AP 6040
PROFESSIONAL SERIES

SERVICE MANUAL

SERVICE BULLETIN

Re : AP6020 / AP6040 Internal Fuse Problem

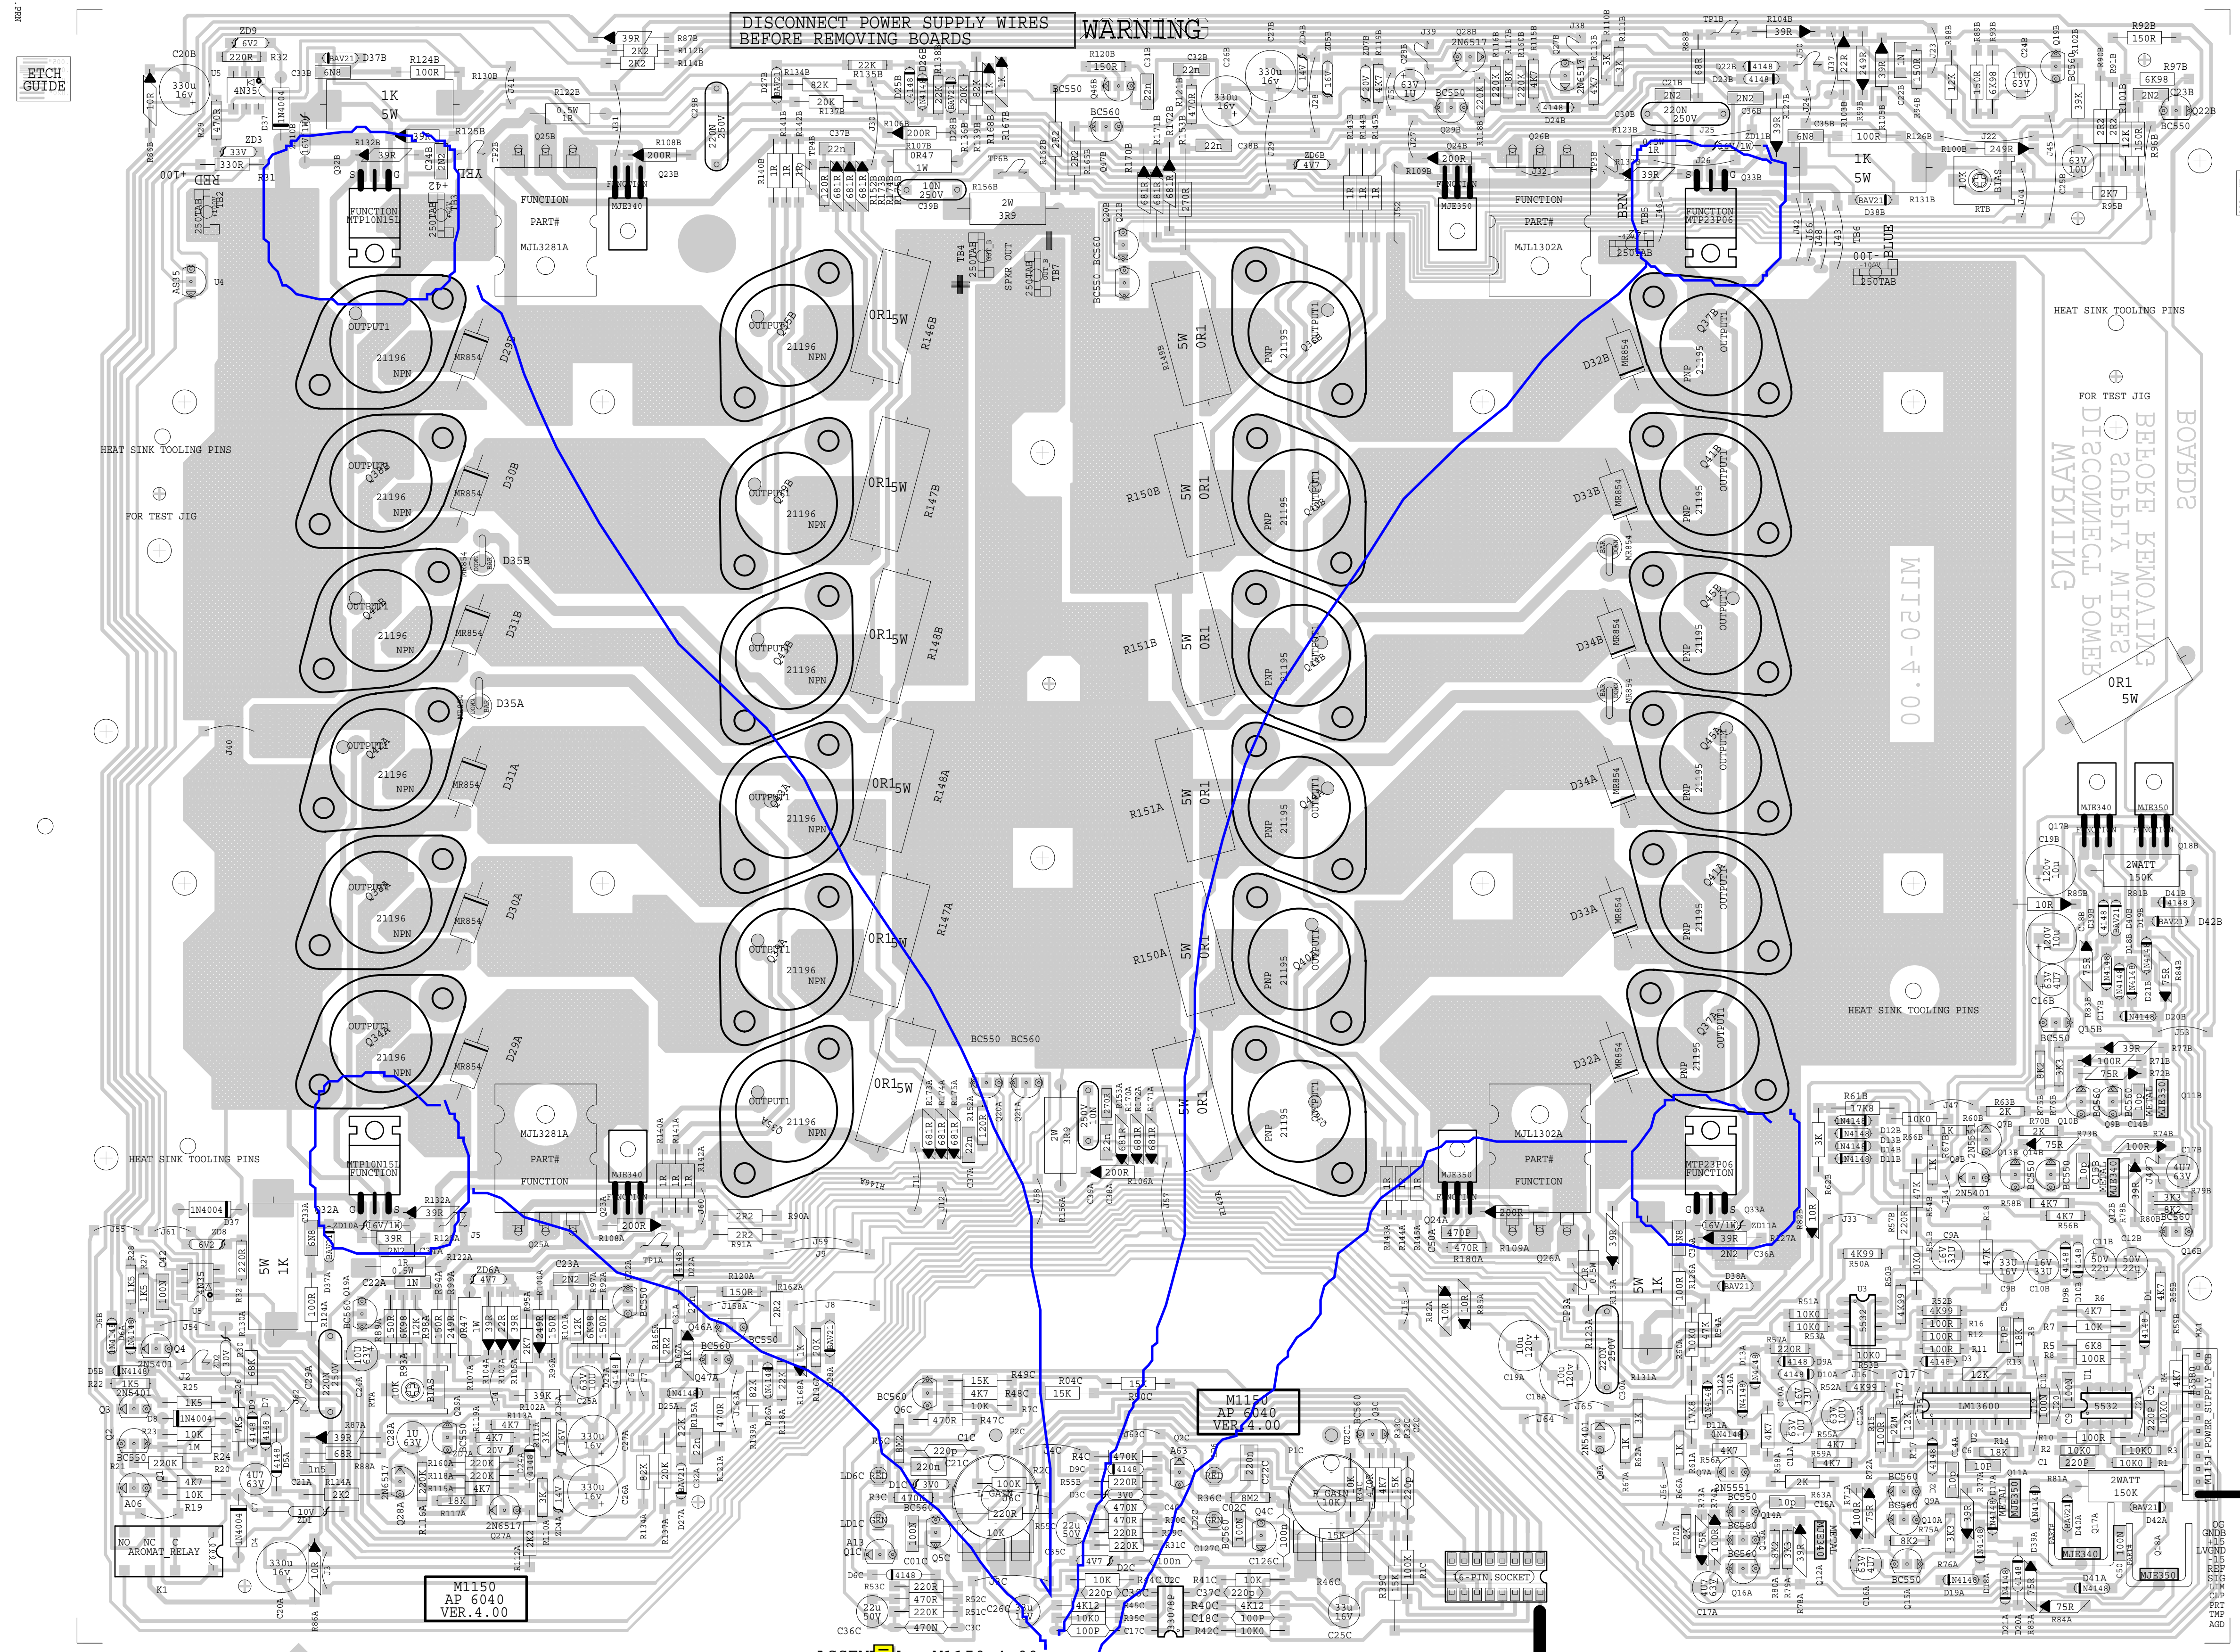
We are sorry to advise that a service issue has developed with the AP6020 and AP6040 power amplifiers that will eventually affect every unit shipped before February 26th, 2000. All units in stock in Canada and the USA have been reworked to correct this problem.

The problem is serious enough that it is necessary to modify all units in the field, so we are here by issuing a service bulletin that will be followed up with letters and phone calls to all affected dealers and distributors.

- Remove the lid from the unit and both power amp boards.
- Locate the small 0.1A fuse on lower power supply board (#M1151 - AP6040 or M1177 - AP6020). This is the only fuse in the unit.
- Replace this fuse with a 5W 390R resistor (YSL Part#4736).
- Dress all wires away from the two 5W 390R resistors.
- In order to be sure that no damage was done to the upper power amp boards when they were removed it is strongly advised that the technician carefully retouch the solder on the three legs of each of the following transistors: #Q32A, Q32B, Q33A and Q33B on each of the two power amp boards (AP6040 - M1176/M1176A, AP6020 - M1150/M1150A)
- Replace the upper boards and lid.

AP 6040
M150
VER.4.00

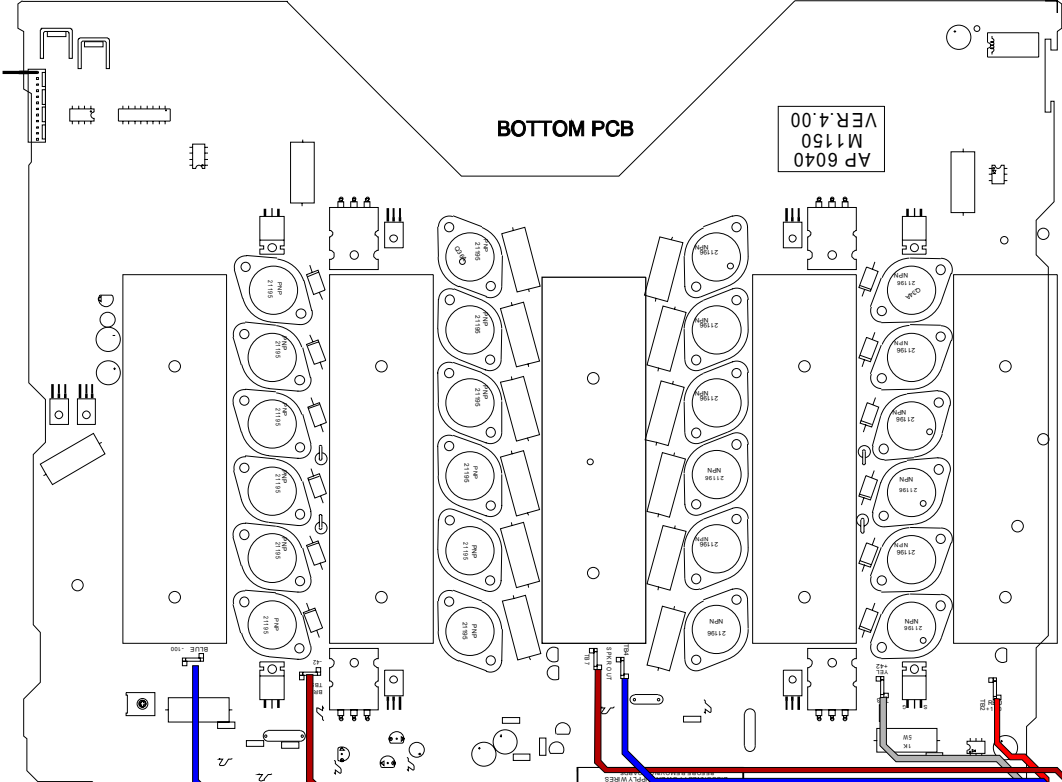
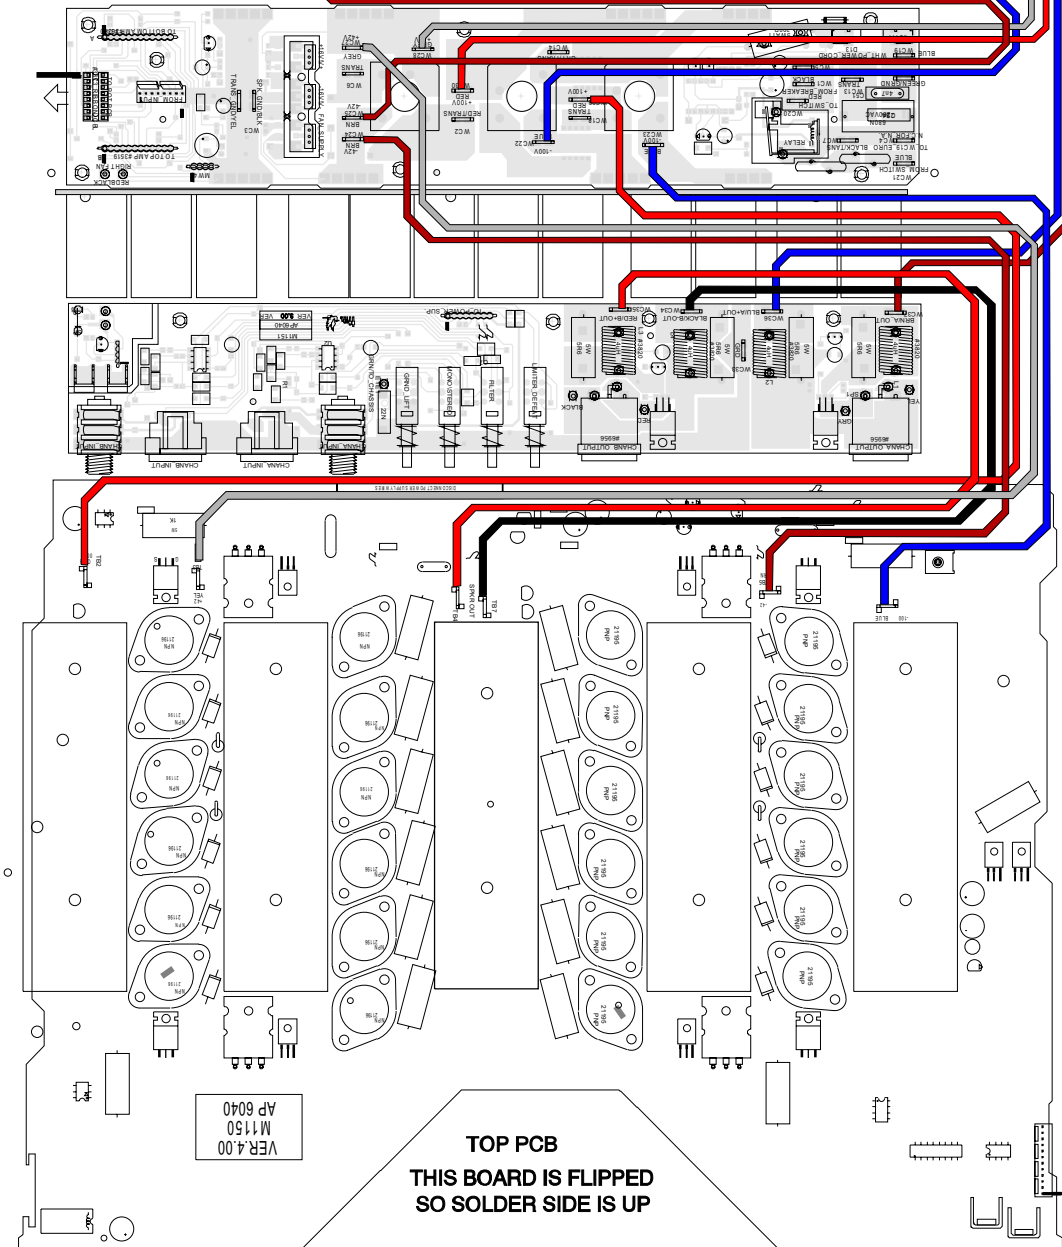
THIS CONNECTION
 MUST BE BROKEN HERE
